RE: Countersignature Permit; Submission Number HNR-EXFE-SV4Z9  
Question and Clarifications

The Barry County Drain Commissioner (Applicant) has reviewed the Draft Countersignature Permit sent on December 23, 2020 for Site 08-Delton Rd-Delton. The Authorized Activities capture the proposed work items, however there are some apparent typographic errors that should be corrected. The Applicant is also agreeable to all of the additional permit conditions (Y.1 through Y.36), with the exception of four limitations which would be acceptable with some level of modification and/or clarification. These items are discussed below.

SUBJECT: Draft Permit for Countersignature; Submission Number: HNR-EXFE-SV4Z9;  
County: Barry; Project Name: 08-Delton Rd.-Delton

**Low-Lying Structures near Upper Crooked Lake**

UPPER CROOKED LAKE  
 LOW-LYING PROPERTIES  
 6/24/2020 EXHIBIT 2

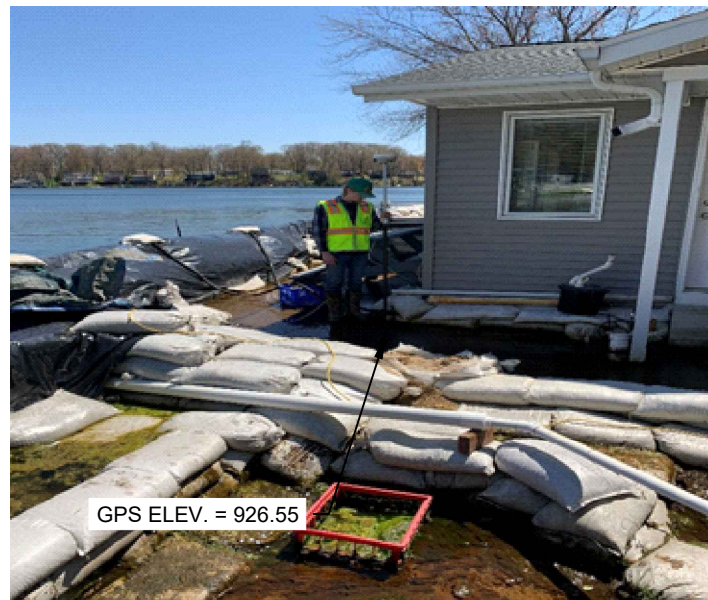
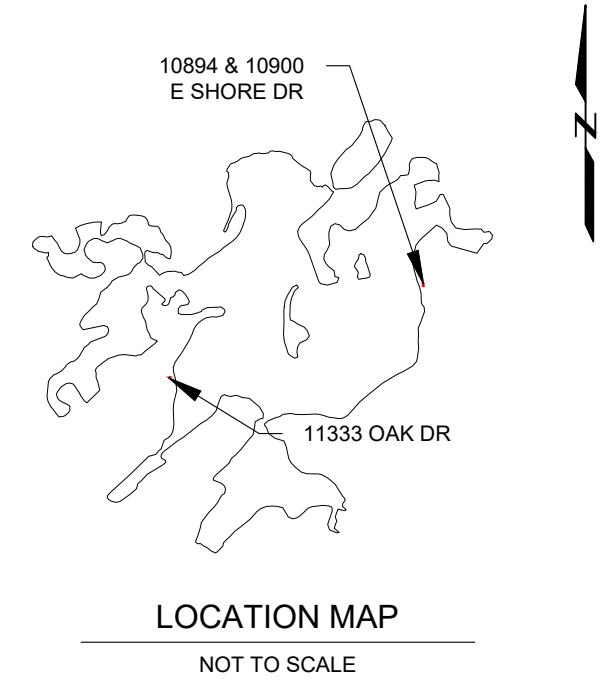
The exhibit in Appendix II was submitted with the July 2020 Correction Request Response and shows the elevation of the ground surface adjacent to the lowest lying permanent infrastructure along Upper Crooked Lake. As can be seen in the exhibit, these critical elevations adjacent to dwellings on the lake range from 926.18' to 927.19.' As written, the permit would not allow for any pumping once the lake was at elevation 926.00,' which is only about 3-inches below the ground elevation adjacent to the dwelling at 10894 E. Shore Drive. It is also worth noting that the surveyed elevations are only the ground surface adjacent to the structures; the structure foundations likely lie a minimum of 12” below the ground surface. Thus, the minimum pumping elevation of 926.00,' would leave the lake extents mere feet from the lowest lying homes and likely result in water above the foundation level. Further, during the wet spring season, the Upper Crooked Lake water level will inevitably rise due to precipitation, runoff and groundwater inputs. A minimum pumping elevation of 926.00' would allow very little freeboard to protect from a precipitation event. For example, between May 13<sup>th</sup> and May 19<sup>th</sup>, 2020, the Michigan State University MAWN Station at Pierce Cedar Creek Institute in Hastings recorded 4.97” of precipitation. According to NOAA Atlas 14 data, this is equivalent to between a 5-year and 10-year event for a 7-day period.

This 4-5” water level rise was in spite of on-going pumping from the lake to the Delton Road Infiltration Basin at approximately 6,000 gallons per minute. This data indicates how sensitive the Upper Crooked Lake water level is to periods of increased precipitation and how a freeboard is necessary to allow time for the pumping to draw down the lake following precipitation events without the flooding of permanent infrastructure adjacent to the lake. If the permit were issued as written and no pumping were allowed when Upper Crooked Lake is below elevation 926.00,’ the May 2020 rainfall event described above would have resulted in the flooding of permanent dwellings at 10894 E. Shore Drive and 11333 Oak Drive. A minimum pumping elevation of 925.20’ on Upper Crooked Lake would allow nearly a foot of freeboard from the lowest permanent structure adjacent to the lake. It should also be noted that existing lake level structure between Upper Crooked Lake and Lower Crooked Lake at Parker Road, meant to control the low-water level on Upper Crooked Lake, is set at a court ordered elevation of 922.75’. Thus, the minimum pumping elevation proposed by the Applicant (925.20’) is still nearly 2.5 feet above the court ordered minimum lake level.

- a. Upper Crooked Lake is ~~926~~ **925.20** feet in elevation or lower.”
